SPECIAL USE REPORT

▶ **FILE #:** 1-D-21-SU **AGENDA ITEM #:** 31
 POSTPONEMENT(S): 1/14/2021-2/11/2021 **AGENDA DATE:** 3/11/2021
 ▶ **APPLICANT:** ACRE KINGSTON PK, T5, LLC
 OWNER(S): E. F. Wheeler Jr

▶ **PROPOSED USE:** Vehicle Repair/Service business (oil change) & Drive-Through Facility (coffee shop)

TRANSPORTATION IMPACT LETTER & OTHER SITE CIRCULATION CONCERNS

SCALE: 1"=20'
DRAWN BY: AIA
CHECKED BY: TS
PROJECT MANAGER: THED STONE
JOB #: 2000210
FILE CODE: DESIGN
SHEET NO.: C-3.0

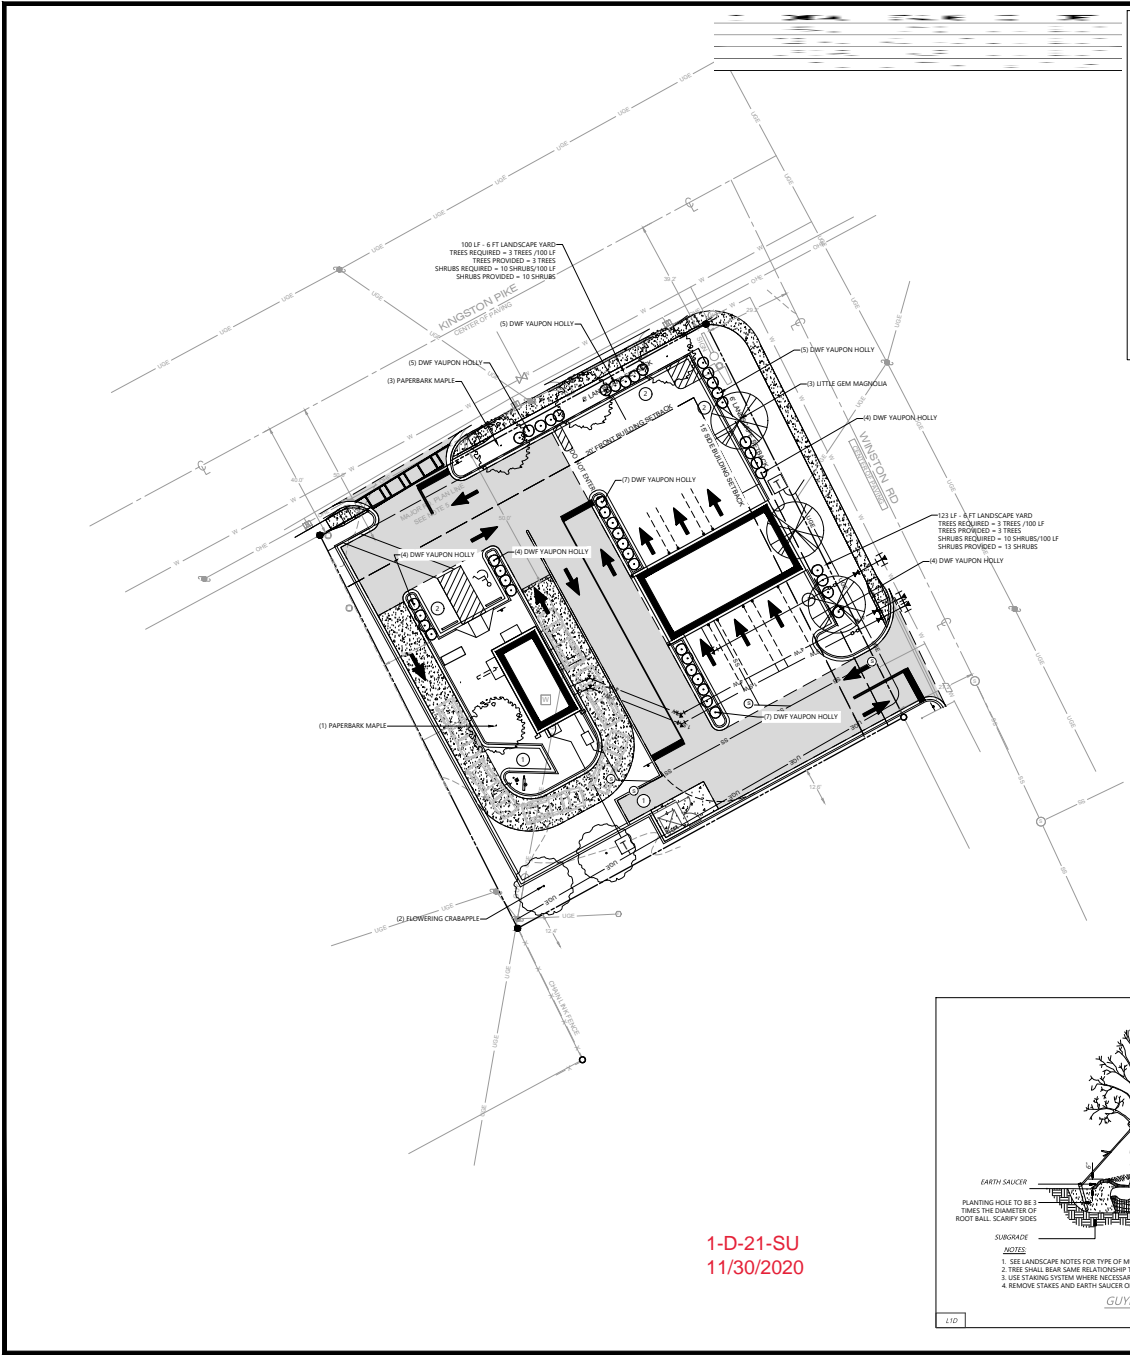
- 1) The letter does not address conflicts at the throat of the Kingston Pike driveway. If there is one car waiting to exit onto Kingston Pike, it could restrict incoming vehicles from going to the Take 5 side of the site and block traffic on Kingston Pike. The TIL only addresses number of cars the drive-through lane can accommodate without impacting the driveway at Kingston Pike.

- 3) The conflicting left turns with the development on the opposite side of Kingston Pike were not addressed.
- 4) A turn template needs to be provided to show how vehicles can maneuver through the tight site. For instance, can a vehicle leaving the Scooter's Coffee drive-through lane exit at the Winston Road driveway without making a multi-point turn near the Kingston Pike driveway.
